PLANNING AND DEVELOPMENT SERVICES STAFF REPORT

For Planning Commission Meeting of July 5, 2017

SUBJECT: 1140 Broadway Conditional Rezoning and Site Plan with Planned Project and Chapter 62 Landscape Modifications

File No. SP17-009, Z17-0003

Figure 3: Site Layout Graphic

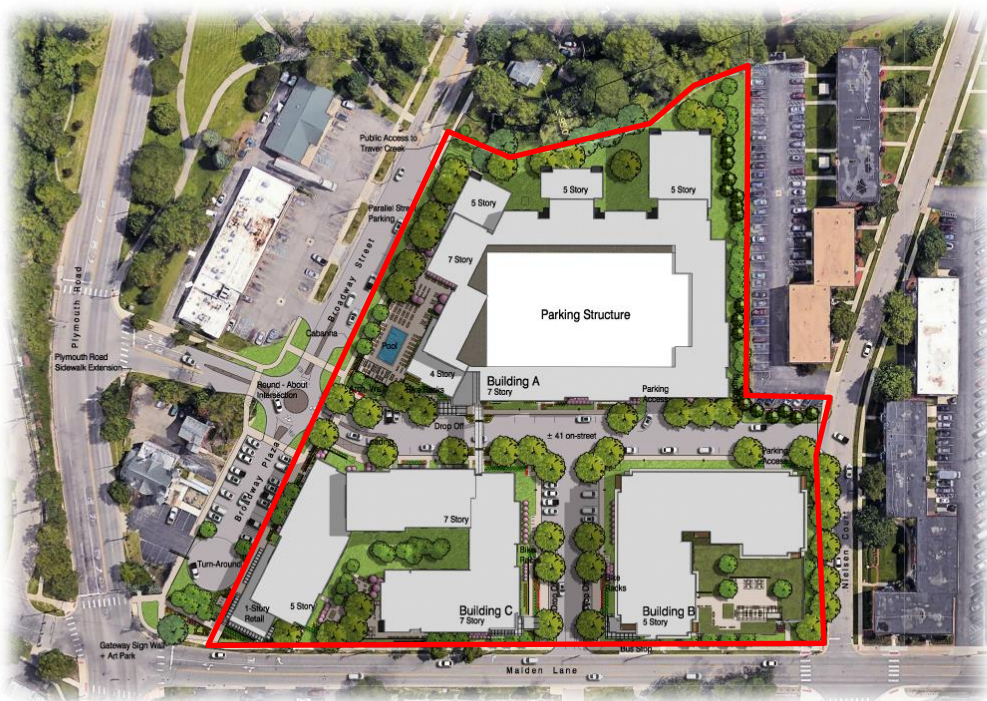
Staff Comments – Staff support the planned project modifications for all requested setbacks except Building A pool enclosure. The other planned project modifications will provide an arrangement of buildings that provides a public benefit (per item 2f above). However, allowing a solid 8-foot wall to enclose a private cabana and pool 2 feet from the front property line – hence 2 ½ feet from the public sidewalk – is not a pedestrian-friendly feature, does not activate the streetscape, and is not appealing or harmonious architecture to anyone outside of the development.

Planning – Staff have expressed two fundamental concerns to the applicant. First, the buildings are broad and massive rather than slender. Second, the development is essentially a single use – residential – with accessory retail space, not a mixed-use center. The applicant responded to staff's concerns in a [detailed response](#) on May 1, 2017 articulating how they believe site plan closely adheres to the vast majority of Master Plan's suggestions. While the applicant respectfully disagreed with staff's comments, we feel that these issues remain and should be discussed by the Planning Commission.

Figure 4: Proposed Open Space Plan

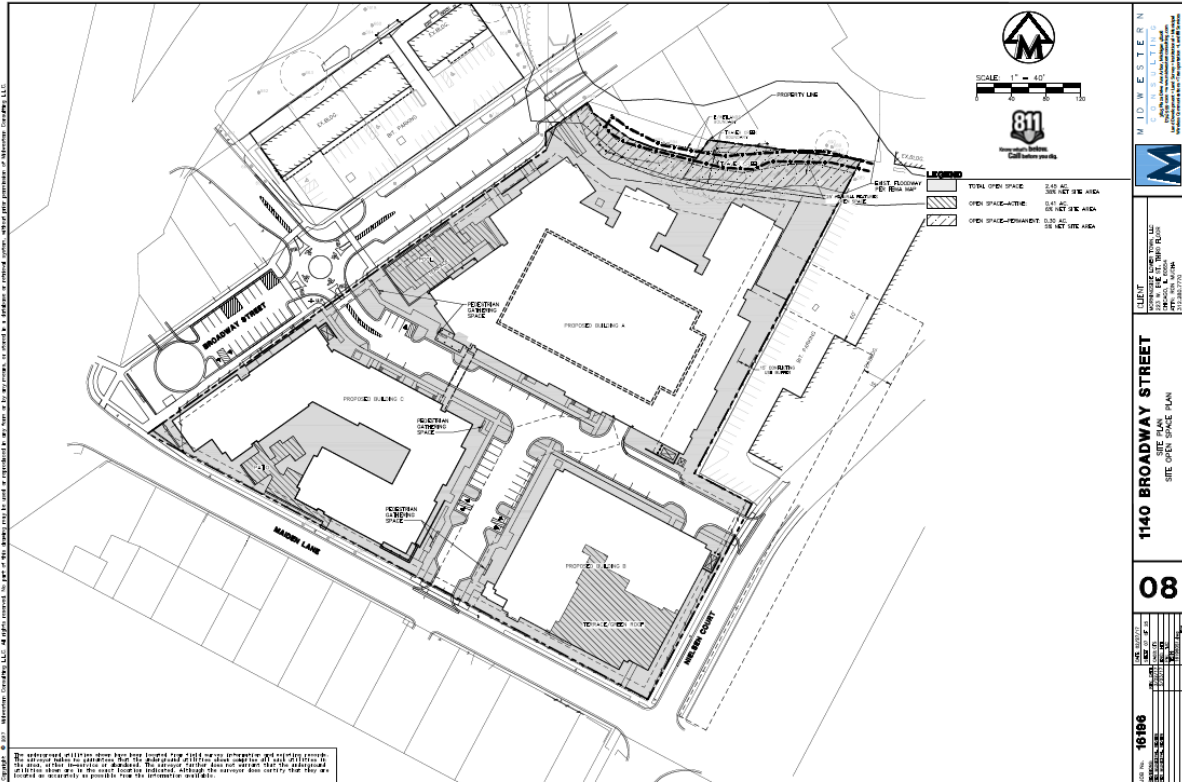
Regarding the proposed access easement across a portion of the buffer, staff do not believe that benefit will outweigh the detrimental effects to the buffer and the watercourse from people (and possibly their pets) in such close proximity to Traver Creek. The 279,222-square foot site has ample room to include both a mixed-use urban village with formal sidewalks and informal pathways throughout without encroaching into the 25-foot wide, 7,964-square foot buffer along the creek. This proposed permanent activity will also ensure a future, permanent activity into the 25-foot required buffer extending onto the adjacent site should that multiple-family development ever be redeveloped. Staff does not support the permanent activity of placing a public access easement over any portion of the natural feature open space.
